BOARD DECISION NR 2008-01

NRCB Application No. 0603

Alberta Environment and Alberta Infrastructure and Transportation
Revised Highwood Diversion Plan

April 2008

Figure 7: Stress and Alert Conditions in the Highwood River

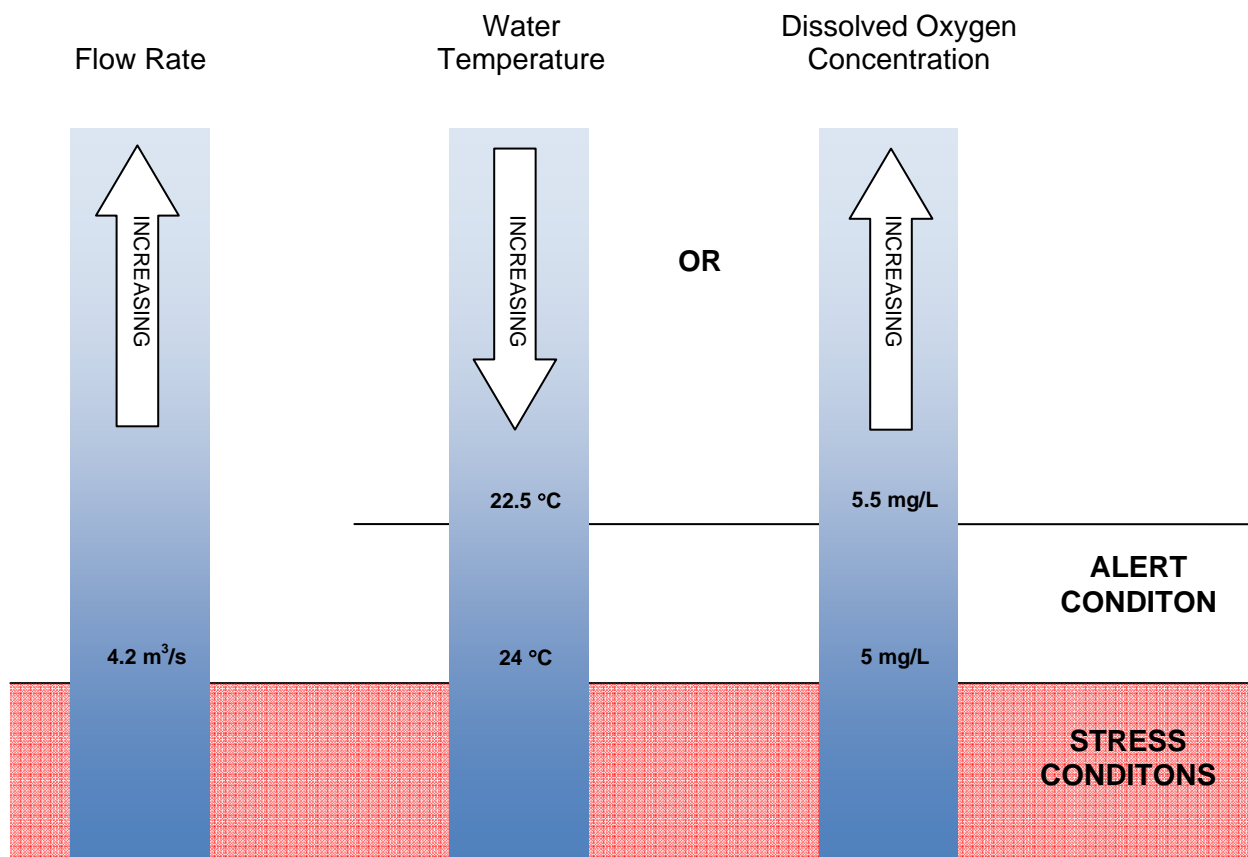
The Board notes that the Diversion Plan does not provide details on the procedures and conditions for declaring an Alert Condition related to drought or flood conditions in the Highwood River. The Board recommends that these procedures and conditions be developed for the Highwood and detailed in the Diversion Plan.
